CS Memorandum No. 1336

Subject: Configuration Management Board Meeting No. 109

CMB Meeting Minutes #109

SUBJECT: Configuration Management Board Meeting # 109 – Rev. No. 0

D-102

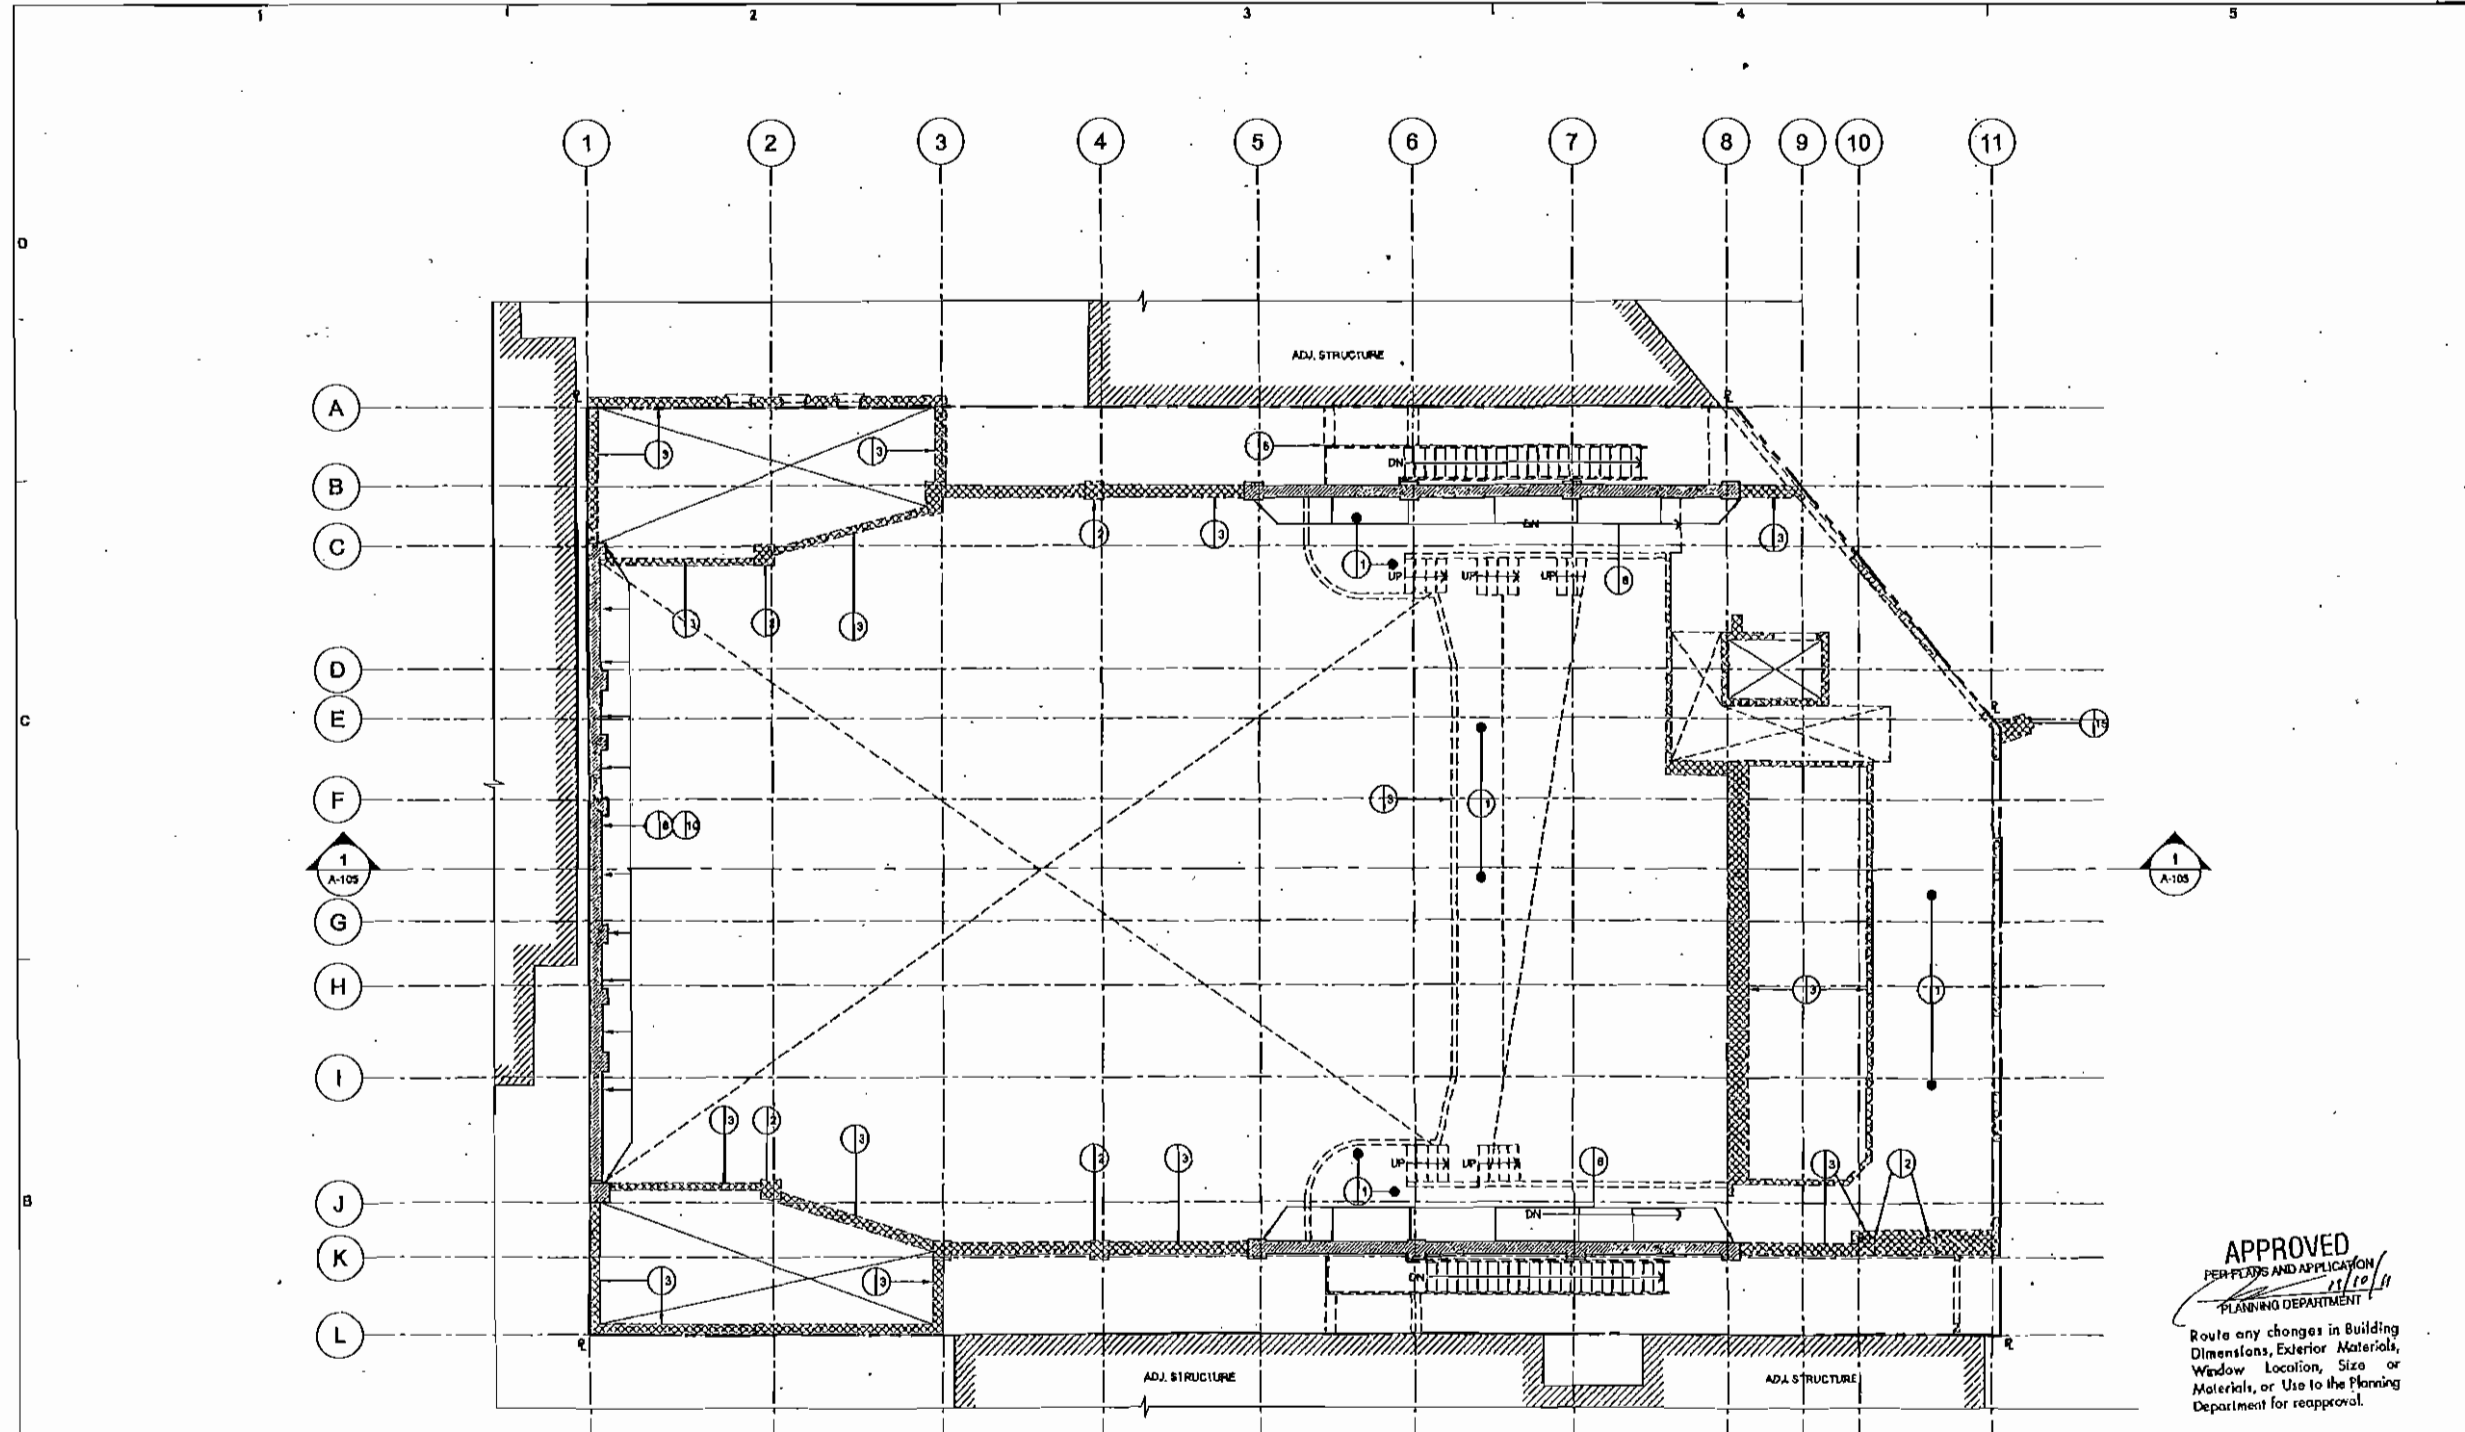
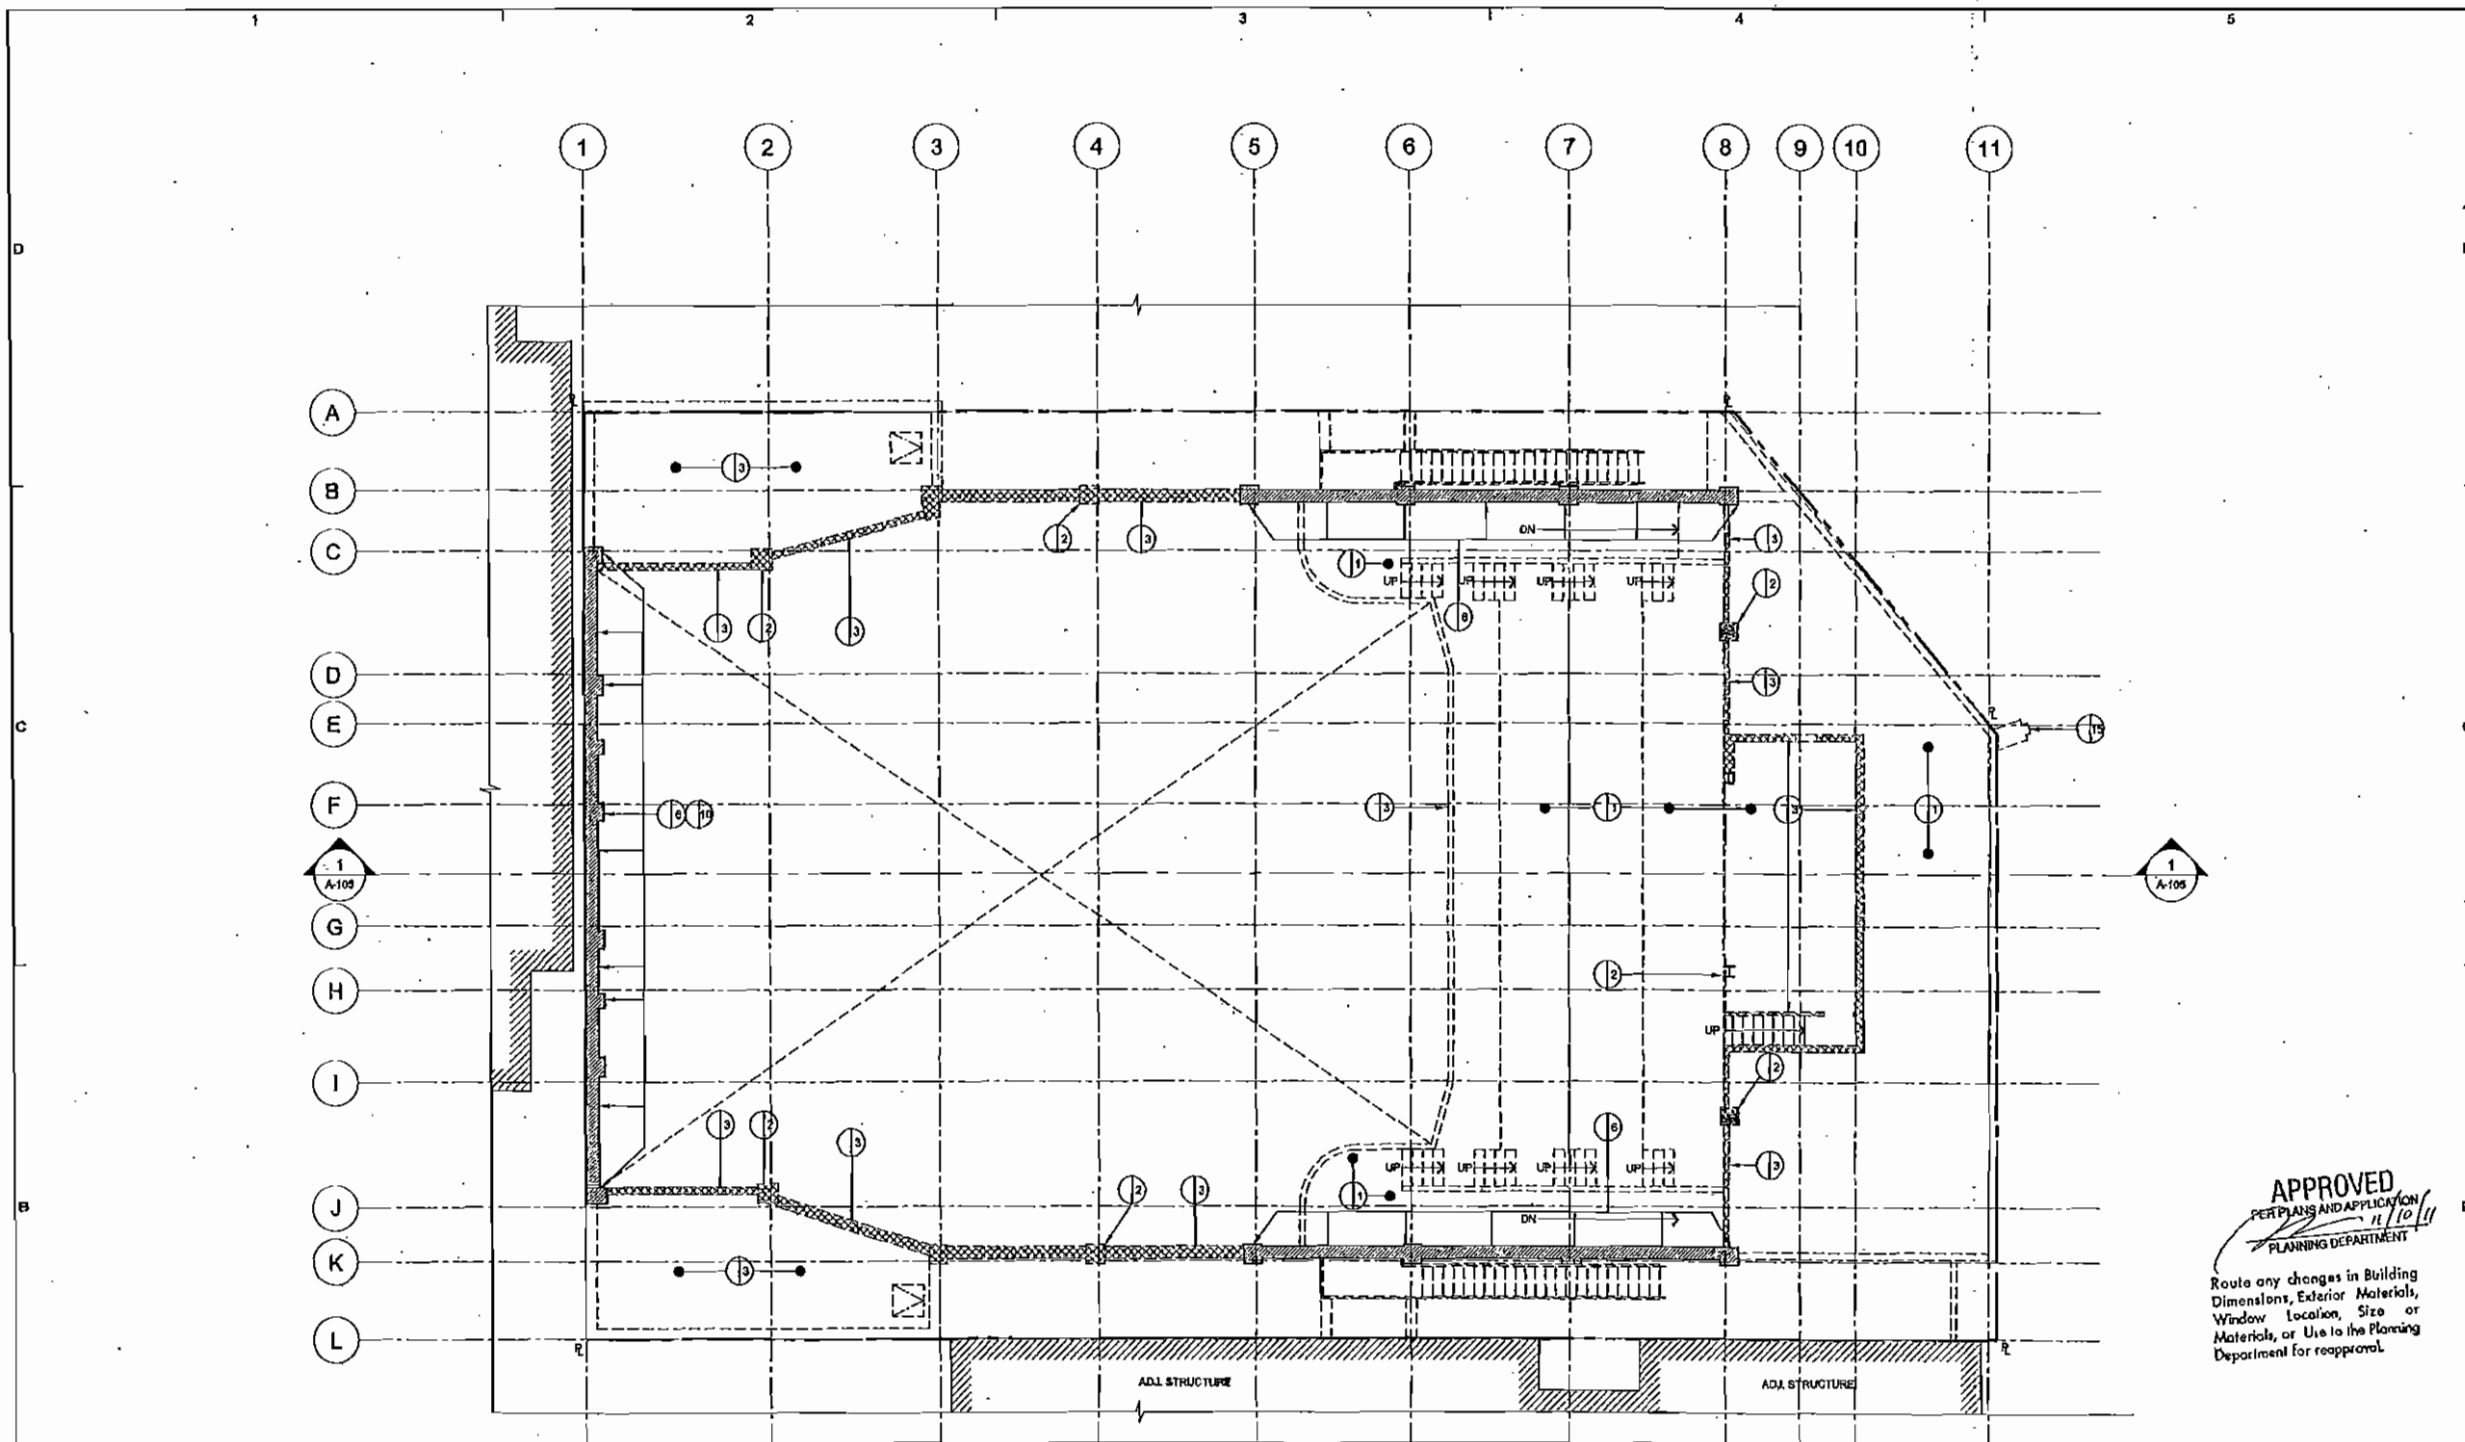
- Design and demolish existing building at 1731-1741 Powell Street. Demolition to include entire building; roof trusses and perimeter walls are not to be retained as shown in attached representative Demolition Plans.
